Wisconsin Department of Transportation

Proposal #08: 6090-06-75, WISC 2015 572
Main Street, City of Waupun
County Park Rd. to State St.
STH 49
Dodge / Fond du Lac Counties

This is Addendum No. 01, which provides for the following:

ADDENDUM NO. 01

Addendum No. 01
ID 6090-06-75
Revised Sheet 161
October 30, 2015

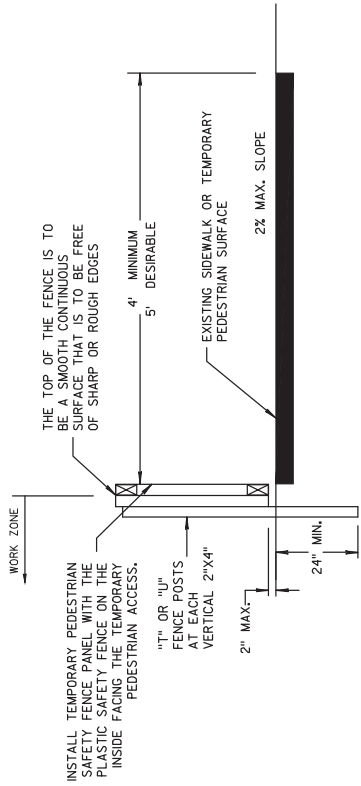
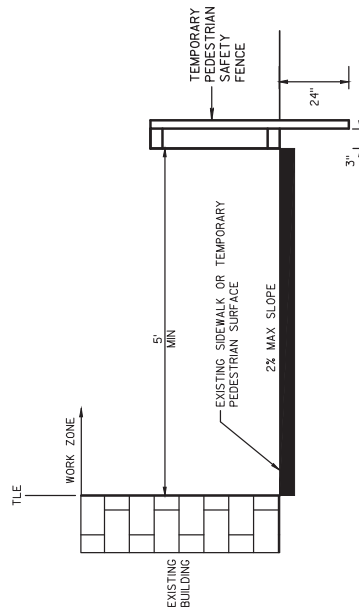
Revised Plan Sheets	
Plan Sheet	Plan Sheet Title (brief description of changes to sheet)
161	Traffic Control – Pedestrian Access (Changed height of pedestrian fence to range of 36” – 42” and added note)

* HEIGHT ABOVE WALKING SURFACE. ADDITIONAL LENGTH OF BOARDS OR OTHER MATERIALS MAY BE NECESSARY FOR INSTALLMENT AND/OR SUPPORTING THE TEMPORARY PEDESTRIAN SAFETY FENCE.
